Subject: Oslo Bay Apartment Site Plan Review Planning File#: P-12-05-19-01
Request for Revisions-On Hold

Date: February 2, 2021

Re: Oslo Bay Apartments – Critical Areas Report: Third-Party Review

Figure 1. Proposed stormwater outfall locations.

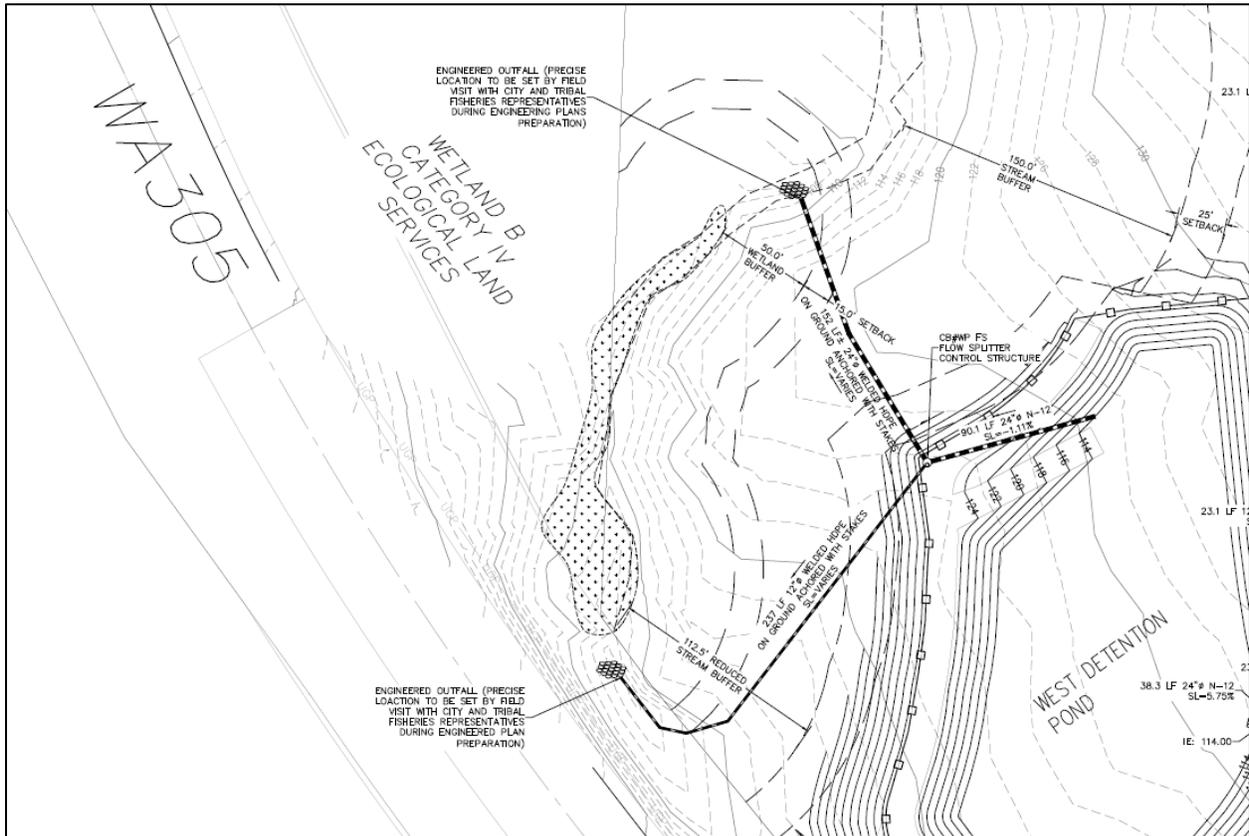
During review of the civil plans Grette Associates identified two additional stormwater outfalls associated with the eastern stormwater pond that are not addressed in the HMP. One would be constructed at the edge of the wetland buffer associated with Wetland A and the other would be constructed near Highway 305, near Wetland A's boundary. Both of these outfall pipes are noted to be 24 inches in size and would be equipped with a flow control device installed where the two pipes connect. Please note that CCS's hydroperiod analysis (August 24, 2020) shows both outfalls being positioned at the edge of Wetland A.

Based on the information provided in the HMP and the inconsistencies identified with the outfalls associated with the eastern stormwater pond, Grette Associates cannot concur with the HMP that

there will be no direct and/or indirect impacts that will occur as a result of the stormwater outfalls. In Grette Associates' professional opinion, the sizing of the stormwater outfall pipes (24-inches¹) suggests that there is potential for large volumes of periodic discharge from the stormwater ponds and the HMP does not provide any supporting information that the dispersion pads will be sufficient to prevent scouring and potential water quality issues. In addition, the civil plans show the larger outfall pipe associated with the western stormwater pond being constructed within the Type F2 stream (Figure 1). This is inconsistent with the description in the HMP.

- The civil plans provided to Grette Associates show the 24-inch stormwater outfall associated with the western stormwater pond extending into the Type F2 stream (Figure 1). If the civil plans show the correct location where this outfall will be constructed the HMP will need to be revised to address the direct impacts to the stream for compliance with Chapter 16.20 of the PMC;
- Per PMC 16.20.320, the proposed crossing shall not diminish flood-carrying capacity. The HMP needs to provide a brief discussion to demonstrate that the proposed culvert size will not diminish flood-carrying capacity.
